Subject: oil in the air box

Model: Nevada 750

TECHNICAL COMMUNICATION No. 02-2003**17 April 2003**

Subject: engine oil level**Model: Breva V750 i.e.****Frames involved: all**

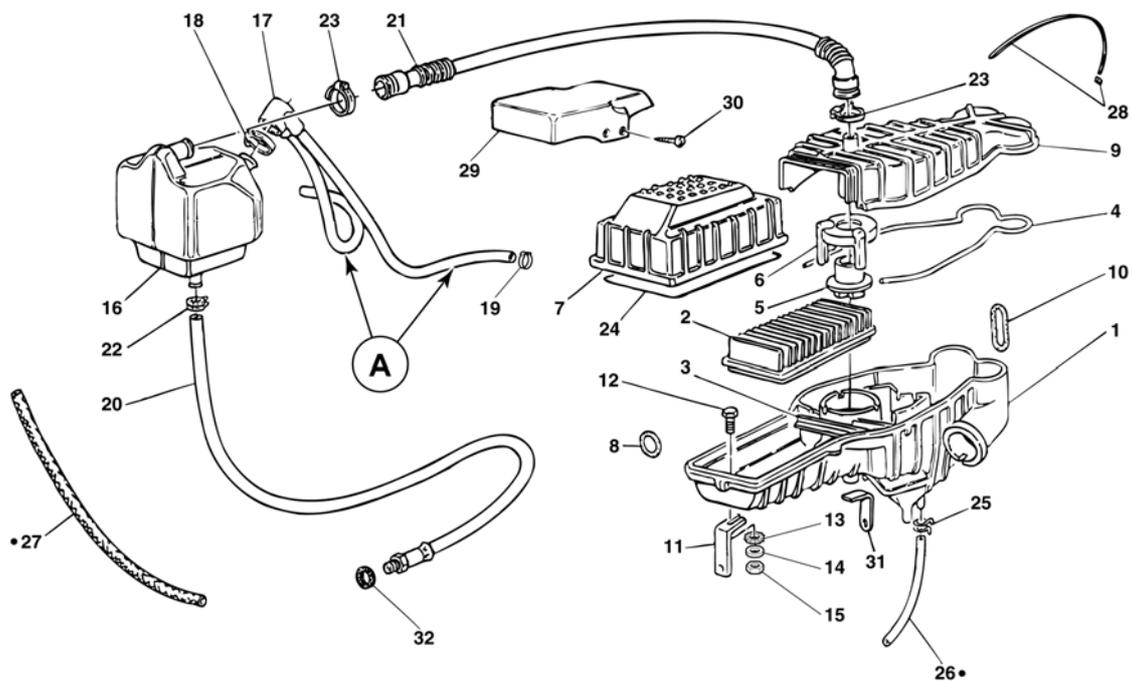
too much oil in the air box

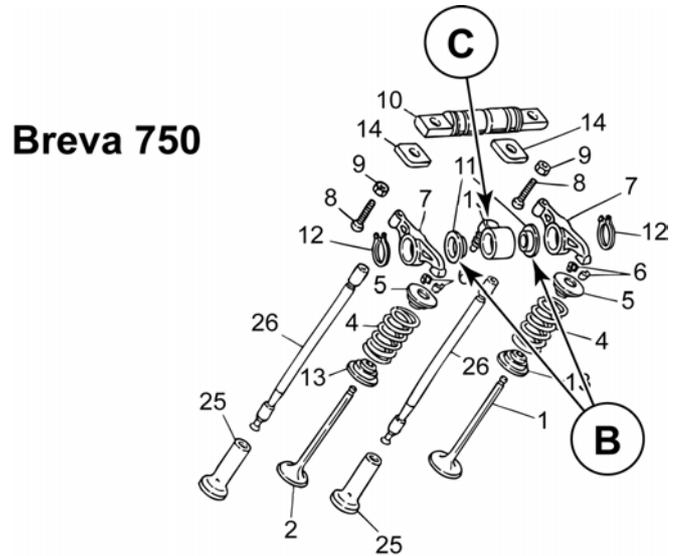
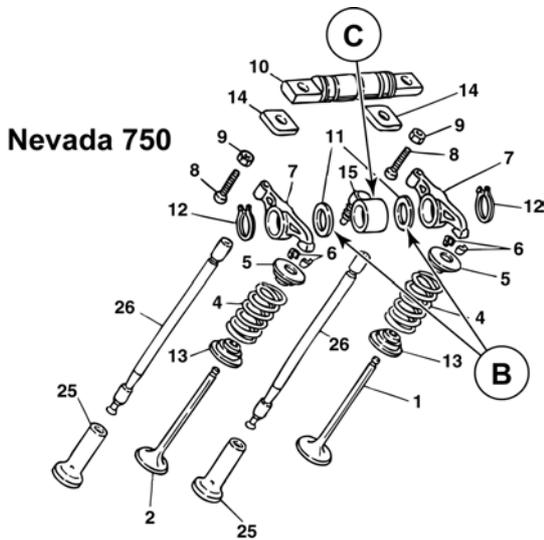
- Check that the two hoses (A) taking the oil vapours from the head covers to the decanter are not squashed due to their flexibility; if so, change them with more rigid hoses.

- Change the hose (C) and the shims (B) with the ones for the Brevia 750 model (for vehicles manufactured before 2003).

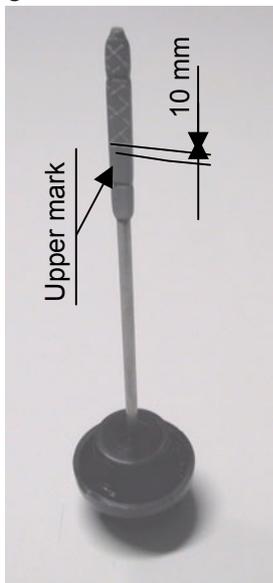
Fault experienced on vehicle: excessive quantity of oil extracted from the oil recover circuit.

Main cause: excessive quantity of engine oil.

Technical solution: check and restore correct engine oil quantity (1.8 kg).

The checking operation can be easily carried out by using the oil filler cap dipstick. The correct quantity of oil wets the dipstick up to around 10-11 mm under the maximum level reference mark. The highlighted part in the photo shows the section of dipstick which must be wet. The check must be carried out with the engine warmed up, after around 20 minutes that it is running.
